Licence Number	L8859/2014/1
Licence Holder	Mineral Resources Limited
ACN	118 549 910
File Number:	DER2014/001998-1
Premises	Iron Valley Iron Ore Project M47/1439 and Miscellaneous Licence L47/757 NEWMAN WA 6753
Date of Report	24 September 2020
Decision	Amended licence granted

Figure 2: Drain connecting to E1 Pit void schematic

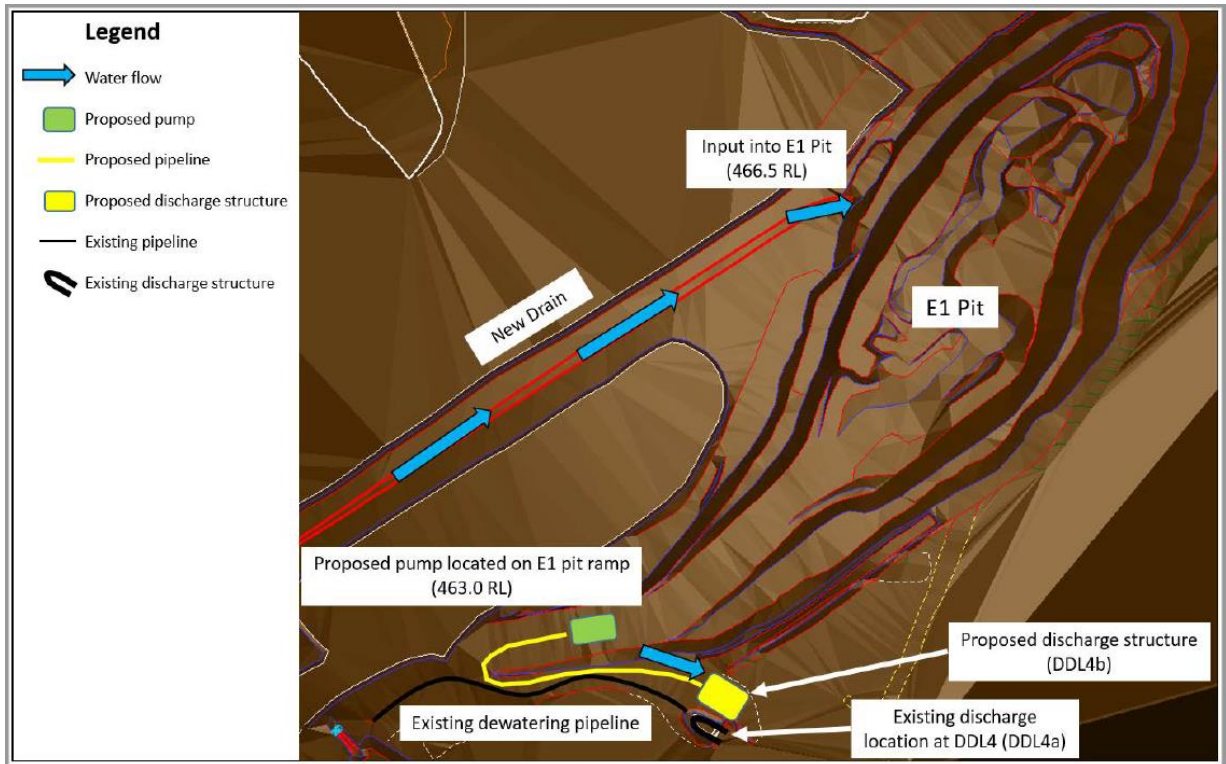
Section 2.1 Purpose and scope of assessment Page 7	Water level within E1 Pit will be maintained at the 462 RL, which will include a freeboard of 3 meters from the lowest point on the pit crest (RFI response dated 05 June 2020 incorrectly stated the maximum pit water level as 452 RL). The total volume capacity of E1 Pit up to the 462 RL is approximately 323,000 kL. Wet weather capacity of E1 Pit will be managed through the existing maximum RL and discharge rates.	Updated
Section 2.1 Purpose and scope of assessment Page 8	As per the RFI response submitted to DWER on 05 June 2020, water will be discharged from E1 pit via a new pump, pipeline and discharge structure. MRL has included a comment in the Amendment Report Draft to reflect this.	Updated
Section 2.1 Purpose and scope of assessment Page 8	Please see revised Figure 2 (Attachment 3) showing water flow and design for E1 pit discharge infrastructure.	Updated
